# City of Beaumont

## Wastewater Treatment Plant Salt Mitigation Upgrade Project

### Change Order No. 21

September 08, 2021

SHEET  
**FSM-1**

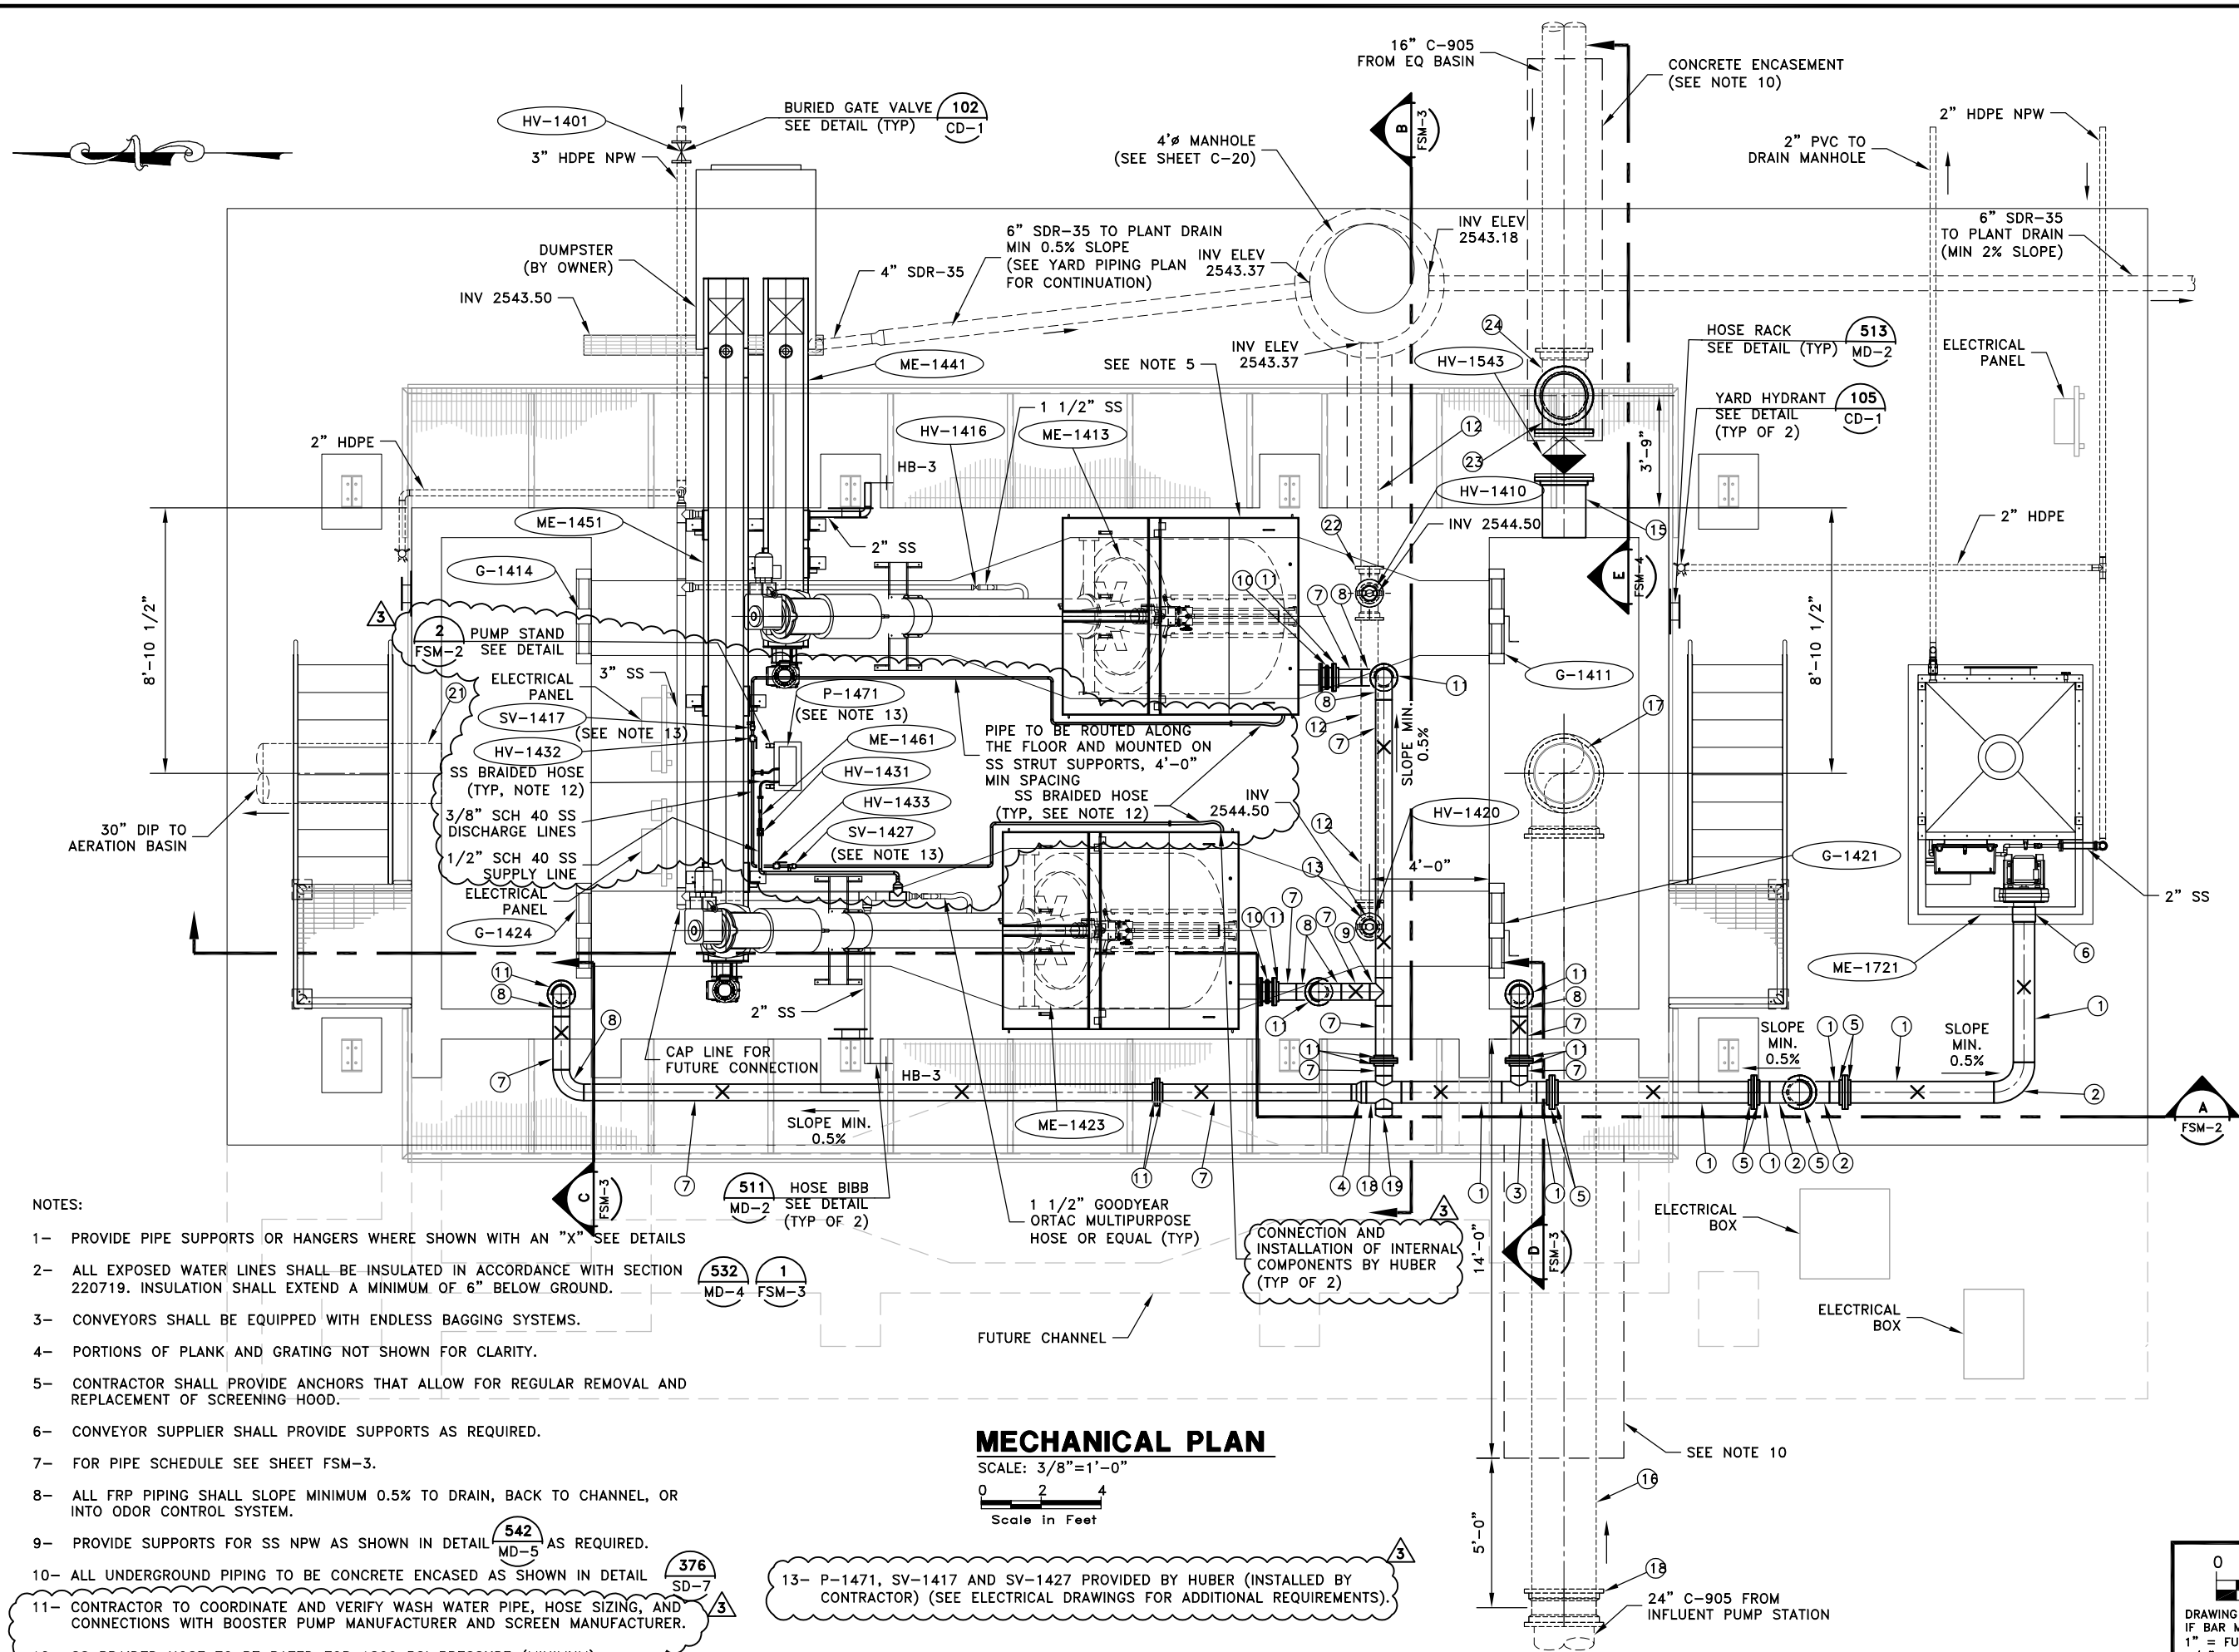
| <p>An optional high-pressure wash system will be installed at the two existing fine screens to minimize the time required for manual washing by plant staff. Huber Technology will provide the required internal screen components, booster pump (P-1471), associated solenoid valves (SV-1417 and SV-1427) and labor required to install the internal screen components. The supply and discharge piping and misc. valves, instrumentation, pump and pipe supports shall be provided and installed by the contractor as indicated in the attached FSM-1 and -2 drawings.</p>  |                                    |

SHEET 9 OF 172  
**PI-05**

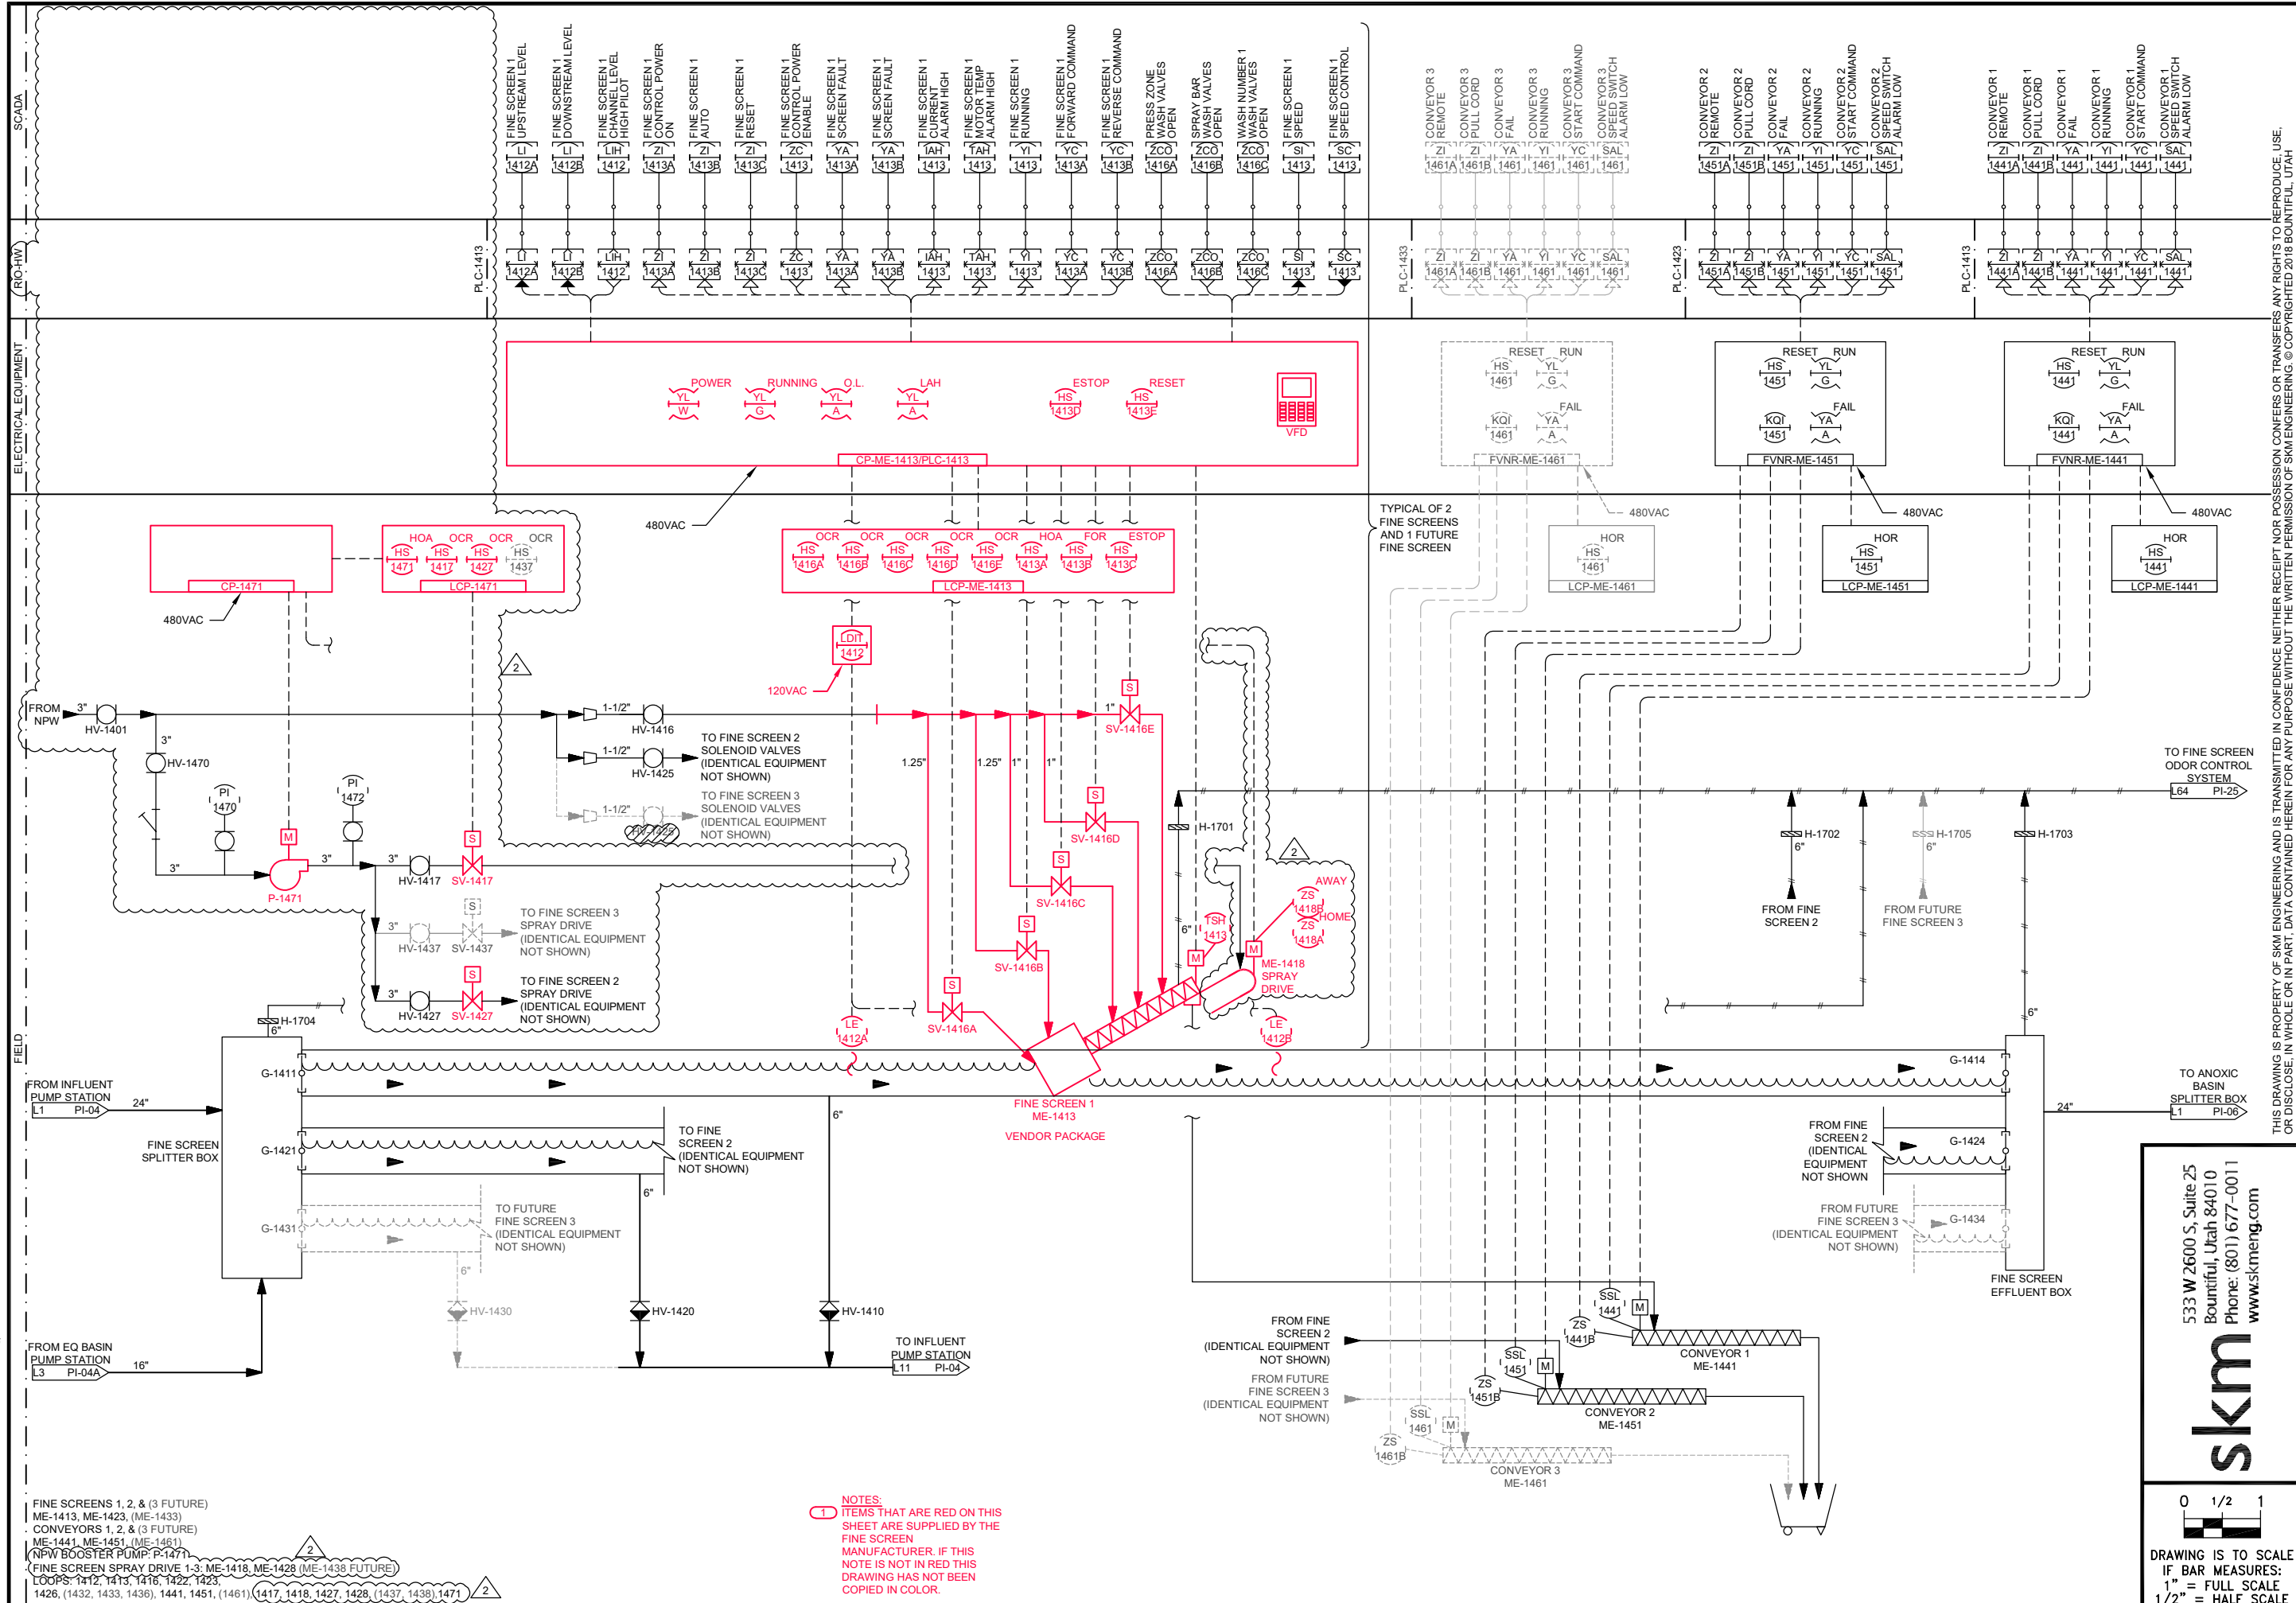
| <p>The installation of the new booster pump will also require the addition of two new pressure gauges, one on the suction line (PI-1470) and one on the discharge line (PI-1472). These will be the same make and model as other pressure gauges installed throughout the plant. See PI-05 and E-17.</p>   |                                    |
